Dowdens Station, LMA G-957, Preliminary Forest Conservation Plan and Preliminary Water Quality Plan

Staff Report Date: 6/26/2015

Dowdens Station Local Map Amendment: G-957
B. Preliminary Water Quality Plan
C. Preliminary Forest Conservation Plan

Request for a Local Map Amendment for reclassification of a 24.37-acre property from R-200 Zone to PD-4 Zone, for the development of up to 105 detached and attached single-family dwelling units, located on the west side of Frederick Road (MD 355), 1,300 feet north of its intersection with Shawnee Lane, known as Garnkirk Farms Parcel N760, part of Lot 21 and Parcel N888 Lot 22 tax map EW31, Clarksburg, 1994 Clarksburg Master Plan and Hyattstown Special Study Area.

Water and Sewer Plan Map: Development Review Inquiries/Research Sewer Service Alignments - Dowdens Station Project

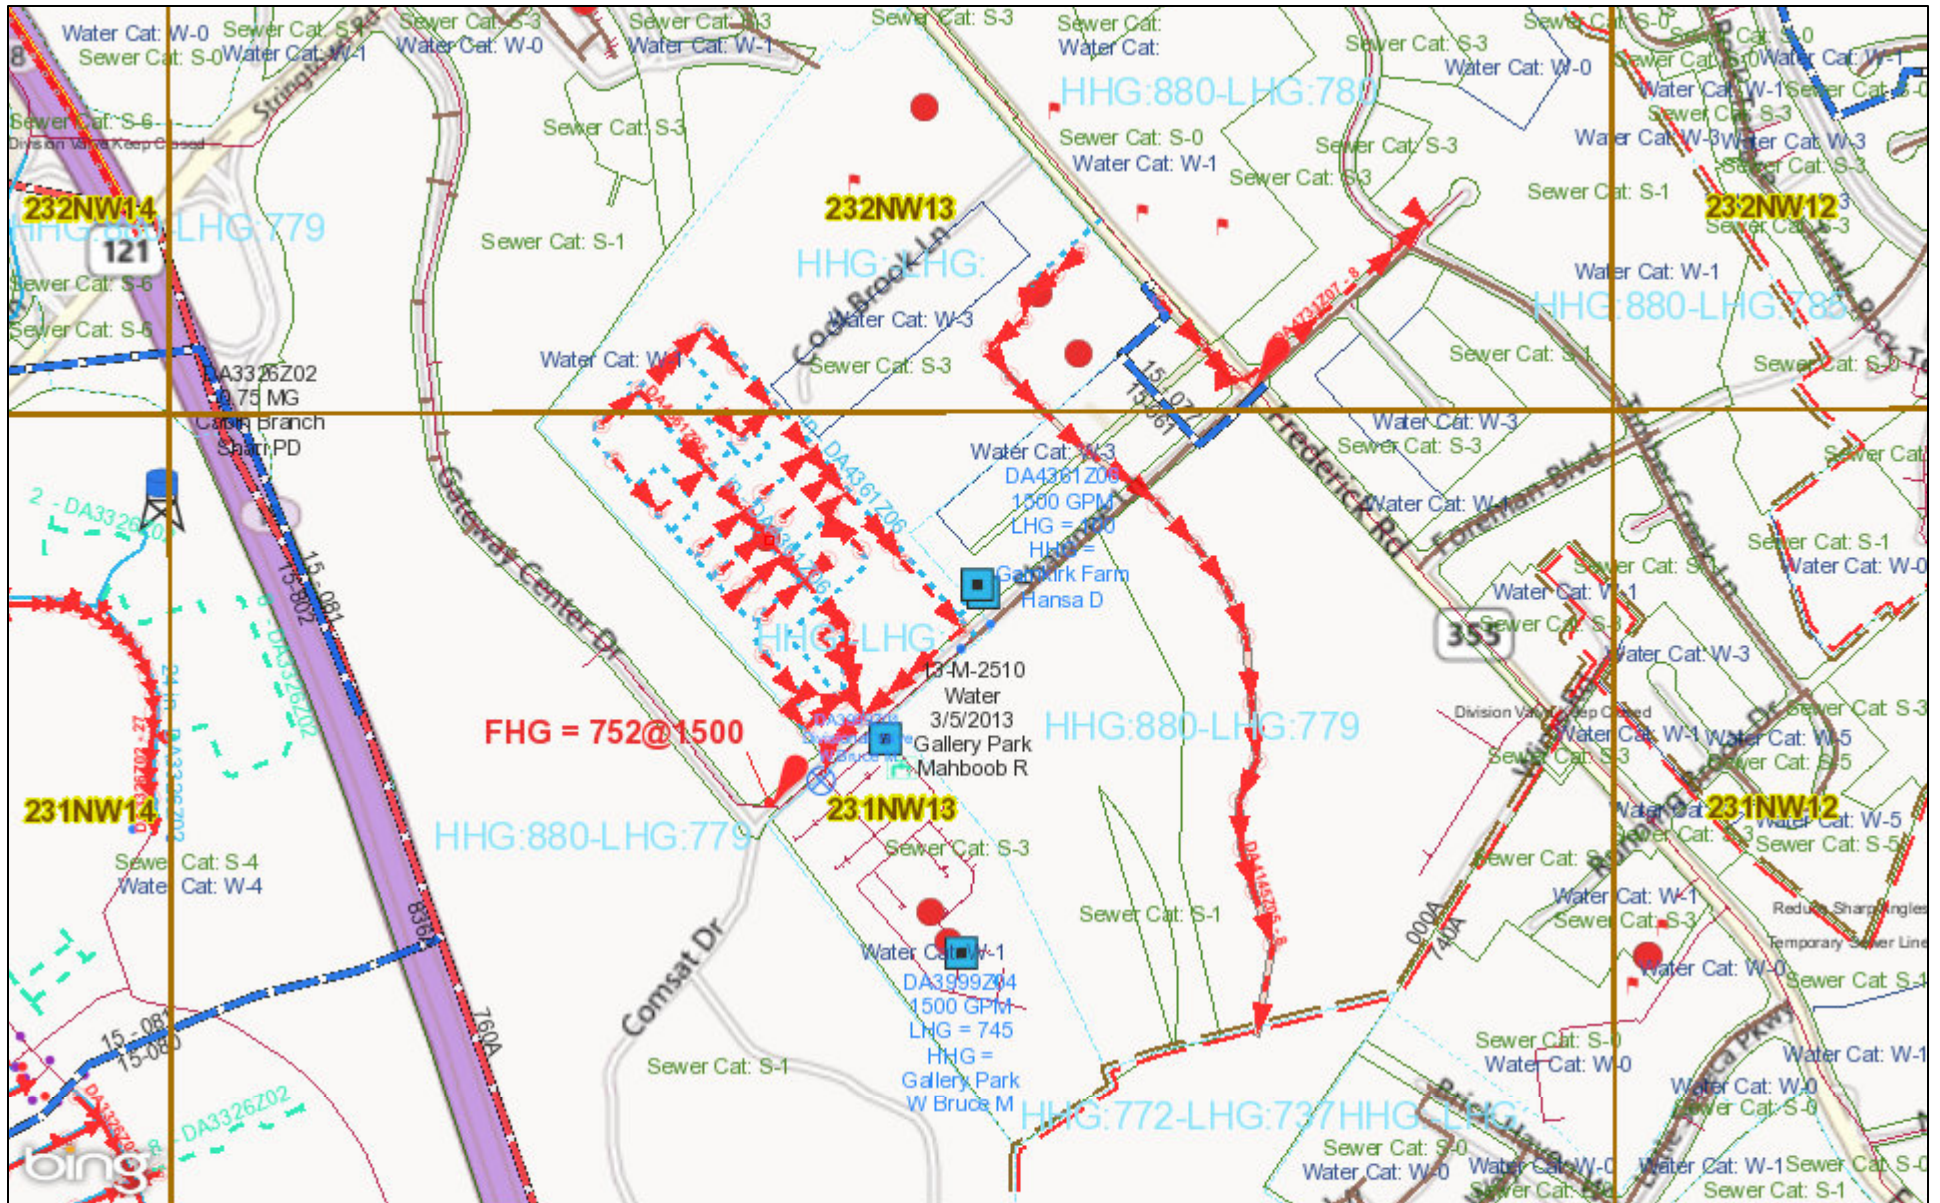
Although not ideal, a modified version of the above solution would be to follow this alignment across the subject area only as far as Shawnee Lane. A pumping station in this location would then pump west over to the outfall in the Eastside subdivision. This modified solution would be subject to WSSC approval.

The attached graphic shows the preferred sewer outfall alignment.

IMPERVIOUS AREA EXHIBIT
PART of Lot 21 & Lot 22 Garnkirk Farms
DOWDEN'S STATION
PLAT # 1982
2nd ELECTION DISTRICT - MONTGOMERY COUNTY - MARYLAND

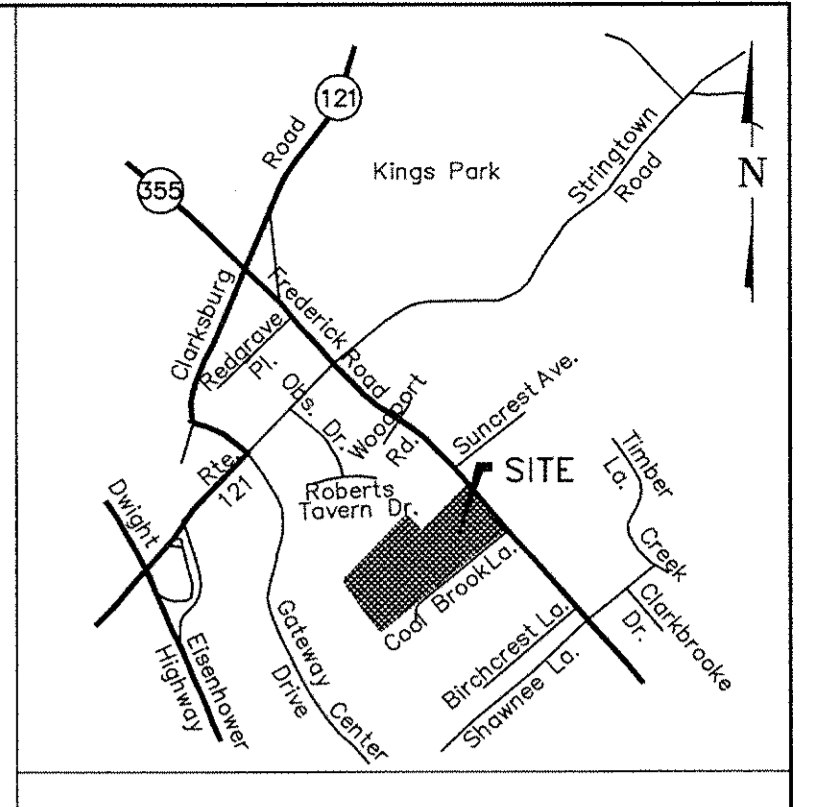
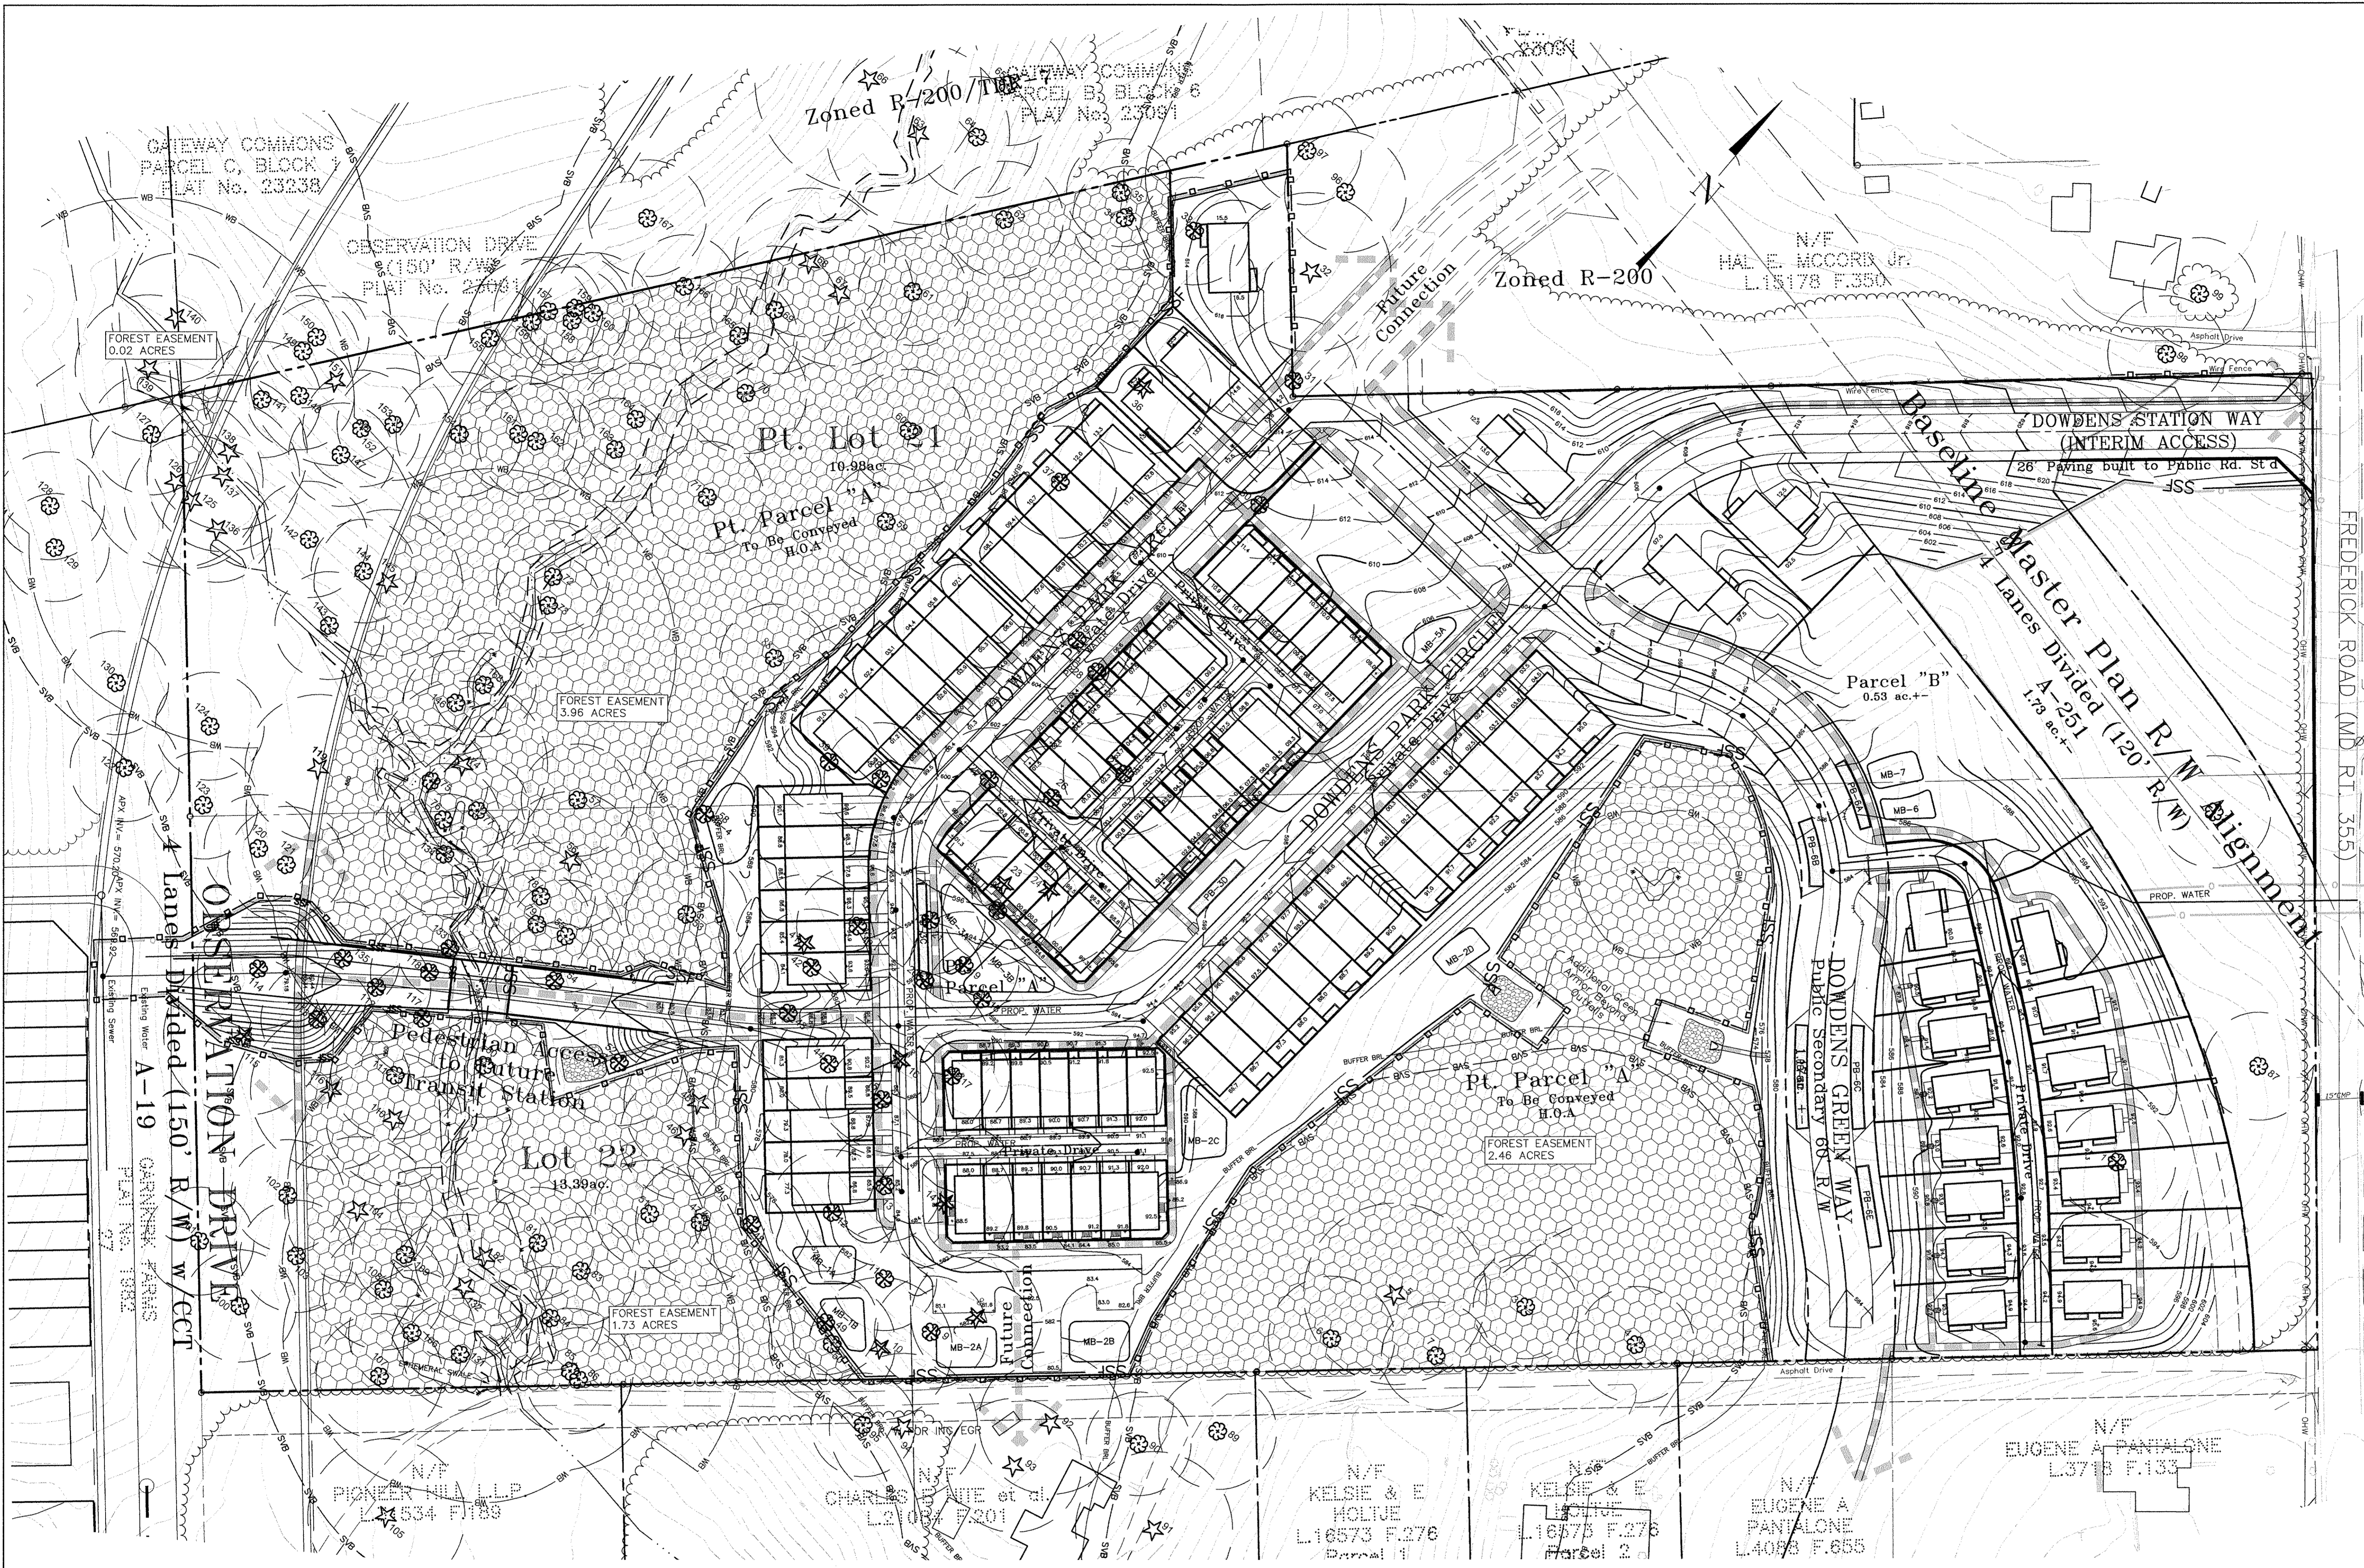
The Impervious Area Exhibit (Attachment D) proposed a post-development condition of 5.6 acres of impervious surface. The percentage of impervious surface shown on the exhibit is incorrect since the area of highway dedication should be deducted from the net tract area as in the forest conservation plan (See Attachment D). This staff report reflects the correct calculation of the impervious percentage by using the same impervious acreage shown on the exhibit. The impervious percentage of the site is 26.0 percent of the 21.57-acre net tract area. The Applicant anticipates the need for additional impervious area as the site development process continues. A future impervious exhibit will include additional elements such as accel/decel lanes, a turn lane on MD 355, site amenities such as play areas and pedestrian connections, additional parking spaces, modified dwelling unit sizes and a wider pedestrian connection across the tributary to Little Seneca Creek. For these reasons, the Applicant has proposed that the final impervious acreage may increase from 5.6 acres to a total of approximately 7.8 acres. This will bring the impervious level to approximately 36 percent of the net tract area.

Because there is no imperviousness cap within this portion of the Clarksburg SPA, the Staff and the Planning Board have historically used the general county range for the zone as a goal. At 36 percent, the proposed project is greater than the expected impervious level of both the R-200 zone and the PD-4 zone. The current impervious exhibit (Attachment D) has minimized imperviousness while attaining the maximum density of the PD-4 zone, resulting in a 26 percent impervious level. The goal of this Application should be to stay below 30 percent of the net tract area.
